# Southampton to London Pipeline Project

Responses to Written Representations -  
Other Parties

Application Document: 8.24

December 2019

WR Para Ref	Point raised	Applicant response to point raised:
		<p><b>Figure 1.1: Current understanding of Cabrol Road Surface Water Flood Risk based on RoFSW Mapping for 1 in 30 (dark blue) and 1 in 100 (light blue) events</b></p>

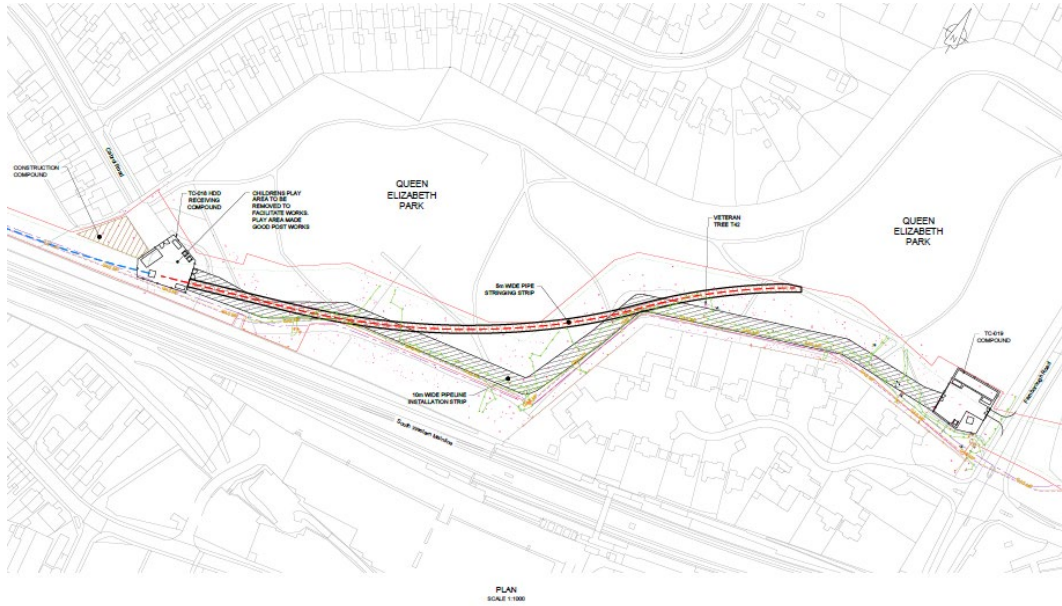
WR Para Ref	Point raised	Applicant response to point raised:
	<p>trees in the park will result in increased flooding in Cabrol Road.</p> <p>4.The construction compound and the activities within it will contribute to an increased risk of flooding in Cabrol Road</p> <p>5.The lower end of the park and gardens in Cabrol Road will be generally wetter all year round due to decreased drainage capacity during and after the project.</p>	<p>Queen Elizabeth Park. This second flow path appears to enter the pond at the western end of the park. When considering the 1% (1 in 100 (Medium)) Annual Exceedance Probability (AEP) extent this flow path does not appear to extend into Cabrol Road.</p> <p>The Rushmoor Borough Council Strategic Flood Risk Assessment (SFRA) (2015), makes no reference to flood history in relation to Cabrol Road based on historic reports provided by the Environment Agency, Hampshire County Council or Rushmoor Borough Council.</p> <p>There would also be no impermeable surfaces introduced during the construction phase.</p> <p>During construction the Applicant does not anticipate having an effect on the flood flow path along Pierrefondes Avenue. The southern flow path through Queen Elizabeth Park is less defined where it enters the Order Limits and the Applicant does not anticipate its work in this area contributing to flows. While the Applicant expects to remove some trees in the southern part of the park, removal of trees would not change the nature of the ground surface, and the ground would remain permeable. Therefore, the project would not change surface water runoff rates as a result of the removal of the trees.</p>

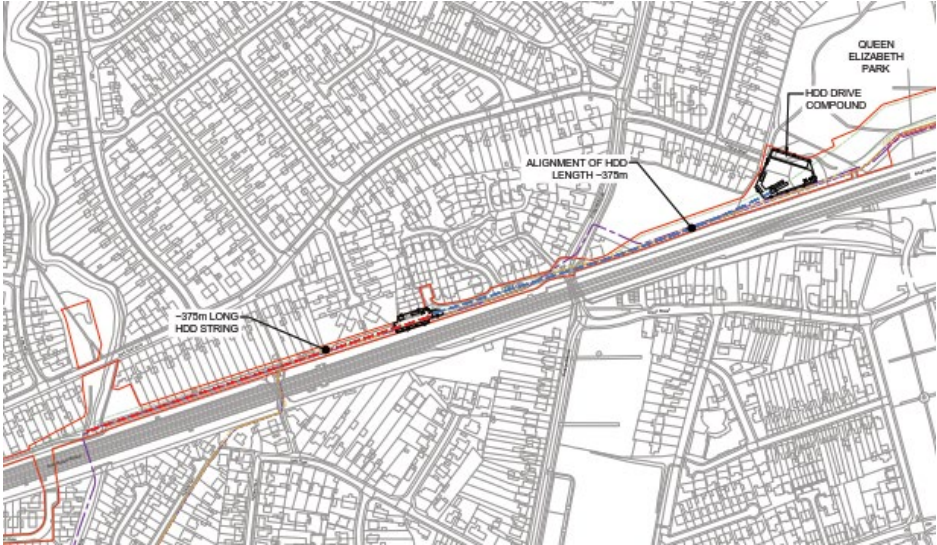
<p><b>Section 2.4.2 Tree loss due to stringing out area</b></p>	<p>1.The stringing out activities and their effects on the park are not documented.</p> <p>2.Stringing out will require the clearance of trees.</p> <p>3.The area cleared for the stringing out activities will be separate from and in addition to any area cleared for trenchless installation (if trenchless installation is used).</p>	<p>In response to point 1, the effects on the park have been fully assessed as a worst-case scenario in the Environmental Statement. Further design detail on the installation methodology is being provided at Deadline 4.</p> <p>In response to point 2 (please refer to ISH2-11 (<b>Document reference 8.20</b>)), some of the younger trees and scrub around the pond would need to be removed, but the mature trees to the east of the pond are well spaced and the Applicant is confident these will not need to be removed.</p> <p>Point 3 is correct. To reduce impacts to trees the Applicant intends to install near the existing pipeline and the path. These both follow the southern boundary of the park, which is not straight. The Applicant then needs a single length of pipe the same length as the trenchless section (from Stake Lane into the park) which needs to be laid out on rollers above the ground so it can be pulled back through. This would be a mostly straight working area.</p>

WR Para Ref	Point raised	Applicant response to point raised:
	<p>4.Narrow working width commitments do not apply to stringing out.</p> <p>5.The exact area to be used for stringing out is not documented.</p> <p>6.Stringing out could require the closure of additional areas of the park.</p> <p>7.The environmental and visual impact statements do not take into account the damage caused by stringing out.</p> <p>8.Mitigation commitments do not cover damage caused by stringing out.</p> <p>9.Esso have not considered reversing the direction of drilling to avoid stringing out within the park.</p>	<p>In response to point 4 the narrow working applies to all works undertaken in the designated sections.</p> <p>In response to point 5, the Applicant is submitting a draft plan to illustrate the 10-metre maximum working area for the open-cut installation and the 5-metre maximum stringing area.</p> <p>In response to point 6 the Applicant is only seeking permission within the Order Limits. The Applicant has committed to a 10-metre-wide working area for open-cut installation and a 5-metre-wide area for stringing through the park to reduce the impact on trees and users of the park.</p> <p>In response to point 7 the Applicant has assessed a worst-case scenario in the Environmental Statement. This covers all activity related to the project.</p> <p>In response to point 8 mitigation commitments cover all works. In addition, stringing is a low impact activity as it is above ground and the pipeline is laid out on rollers.</p> <p>In response to point 9, reversing the direction of drilling was considered and discounted on the basis that it would require stringing along and behind the back gardens of the properties along West Heath road, this would then require vegetation and tree clearance at the base of the railway embankment. The replacement pipeline along this section of the route is being installed by trenchless construction (TC017) to avoid the need for such an event and also to limit the impact on the residents, hence it would not make sense to then impact the residents with pipeline stringing works for TC018. The lengths of pipe material (12m long) to create the string for TC018 in this proposal will have to be delivered to the work site in Stake Lane and a ‘workshop’ area created to weld the lengths together in this location to limit the impact on the residents back gardens of West Heath Lane, and therefore the duration of the works to the area of the former garages of Stake Lane will be considerably longer, with more deliveries for the residents of Stake Lane and Brewers Close. The Applicant has considered that for efficiencies utilising the drive pit from the same location at Stake Lane does mean that the drive unit only needs to be turned around</p>

WR Para Ref	Point raised	Applicant response to point raised:
		<p>in the same location and there is not the requirement to build another drive pit in QEP. To move the drive pit to the play area of the park would introduce a larger mobilisation of plant to the park location. This would result in a larger drive compound and the loss of trees in the south west corner. See sketch below (Figure 1.3).</p> <p><b>Figure 1.3 – HDD from play area in QEP to Stake Lane</b></p> 
<p><b>Section 2.4.3 Tree identification</b></p>	<p>1. Esso has not produced detailed tree identification records for Queen Elizabeth Park.                  2. Lack of detailed tree records prevents the extent of the damage</p>	<p>In response to point 1, the Applicant has provided Appendix 10.2 Schedule of Notable Trees – Revision No. 2.0 (<a href="#">REP2-009</a>) that shows that the trees within Queen Elizabeth Park have been identified as a notable group. Notable trees are defined by the Applicant as prominent trees within the landscape and by nature will generally be the large, mature specimens.</p>

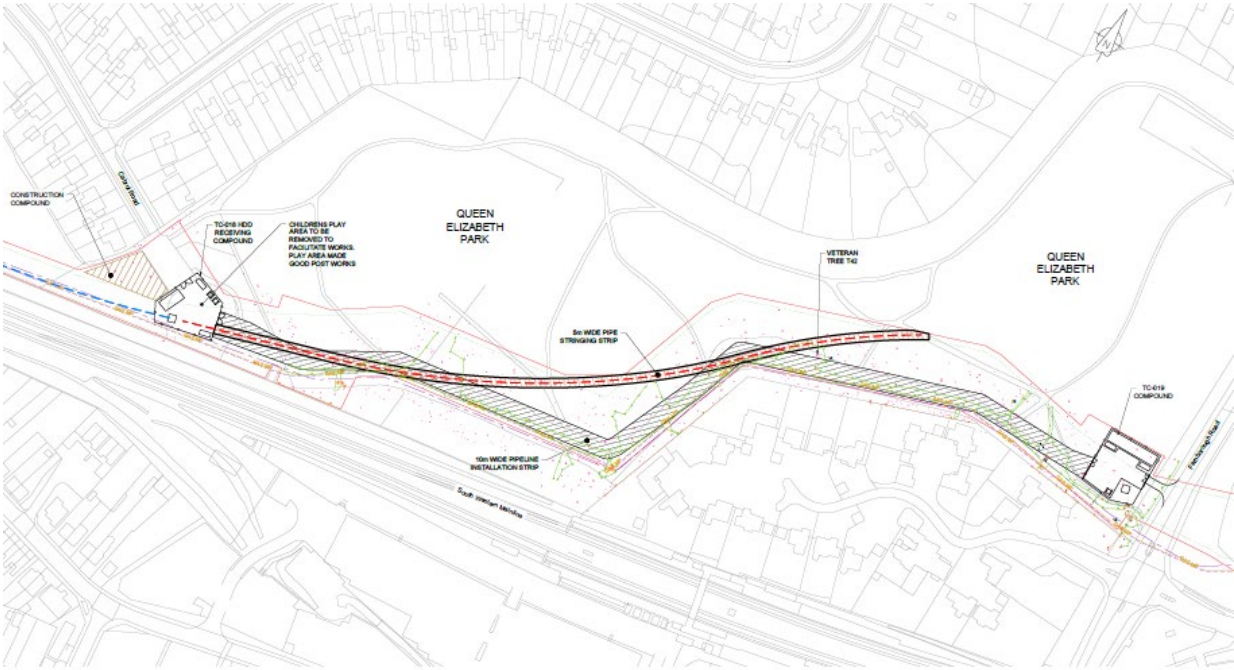
<p><b>Section 2.5 Wildlife Q3-5</b></p>	<p>3. There is no commitment to avoid working during nesting and breeding seasons within the park.</p> <p>4. There is no commitment to prevent disturbance of bird nests and eggs during the project.</p> <p>5. There is no commitment to avoid the use of netting in trees and shrubs to restrict nesting.</p>	<p>Points 3 and 4 are not correct. It is a legal requirement to prevent the disturbance of birds during the nesting season and commitment G35 (<b>Application Document <a href="#">APP-056</a></b>) states that <i>'the assumption would be that vegetation with the potential to support bird nests would not be removed during the breeding bird season (March to August inclusive). If any works become necessary during the breeding bird season, works would be supervised by an Environmental Clerk of Works (ECoW). Appropriate protection measures would be put in place should active nests be found. These would include exclusion zones around active nests until chicks fledge or nests become inactive as determined by monitoring by the ECoW'</i>.</p>

WR Para Ref	Point raised	Applicant response to point raised:
		<p>In response to point 5, the Applicant has no intention to net trees or shrubs to restrict nesting.</p>
<p><b>Section 2.6.1 Drilling between Stake Lane and the play area</b></p>	<p>1.Documentation of directional drilling in and around the park is inadequate.</p> <p>2.It is not clear whether TC018 is the trenchless route which runs beneath the allotments and into the park.</p> <p>3.Documentation about drilling under the allotments is incomplete or not up to date.</p> <p>4.It is not possible to know which direction the trenchless route will be drilled in.</p> <p>5.Whilst temporary loss of allotments is very undesirable, prioritising the allotments, which can be reinstated in a short time over trees, which take many years to replace, is the wrong decision.</p>	<p>The Applicant is providing more detail regarding the working method in the park to the Examination Authority in ISH2-15 (<b>Document Reference 8.20</b>).</p> <p>In response to point 1, the Applicant can confirm that from a directional drilling perspective in the park, there are three elements associated with that activity that would impact the park. The first is the reception pit for TC018, which would be located within the area to the southeast of the park. The second is the pipe stringing out area associated with TC018, which would be strung out through the park along the alignment indicated in the sketch below Figure 1.4. The third is an auger bore for the crossing beneath the A325 (TC019 and the reception pit for this is in the north east corner of the park).</p>
